PIC16C62A Rev. A Silicon Errata Sheet

The PIC16C62A (Rev. A) parts you have received conform functionally to the Device Data Sheet (DS30234D), except for the anomalies described below.

FIGURE 1: SCK PULSE VARIATION USING TIMER2/2

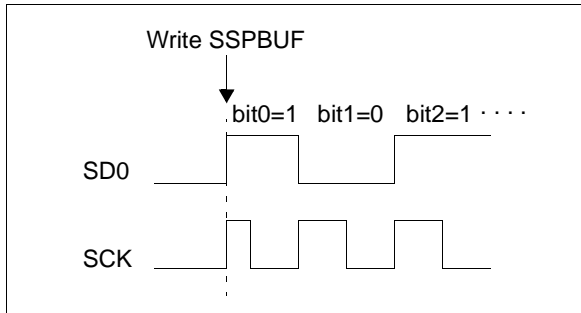
When the SPI is using Timer2/2 as the clock source, a shorter than expected SCK pulse may occur on the first bit of the transmitted/received data (Figure 1).

To avoid producing the short pulse, turn off Timer2 and clear the TMR2 register, load the SSPBUF with the data to transmit, and then turn Timer2 back on. Refer to Example 1 for sample code.

FIGURE 1: WRITES TO TIMER1 (EXTERNAL CLOCK/OSCILLATOR MODE)

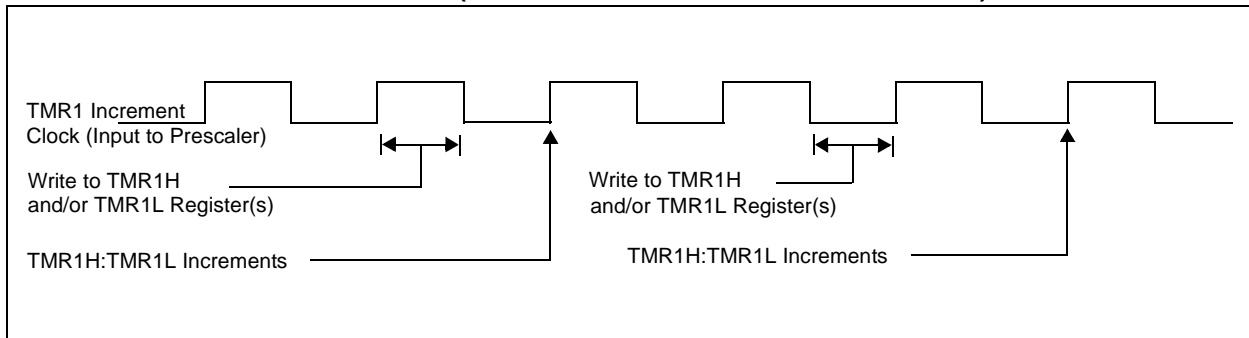
The operation of Timer1 needs some clarification when the timer registers are written and the TMR1ON bit is set.

The internal clock signal, that is the input to the TMR1 prescaler, affects the incrementing of Timer1 (TMR1H:TMR1L registers and the Timer1 prescaler). When the Timer1 registers are NOT written, the Timer1 will increment on the rising edge of the TMR1 increment clock.

When the TMR1H and/or TMR1L registers are written while this clock is high, TMR1 will increment on the next rising edge of this clock.

When the TMR1H and/or TMR1L registers are written while this clock is low, TMR1 will not increment on the next rising edge of this clock, but must first have a falling clock and the rising clock for TMR1 to increment.

Figure 1 shows the two cases of writes to the TMR1H and/or TMR1L registers. Due to the V_{IH} and V_{IL} thresholds on the oscillator/clock pins, external Timer1 oscillator components, and external clock frequency, the Timer1 increment clock may not be of a 50% duty cycle.
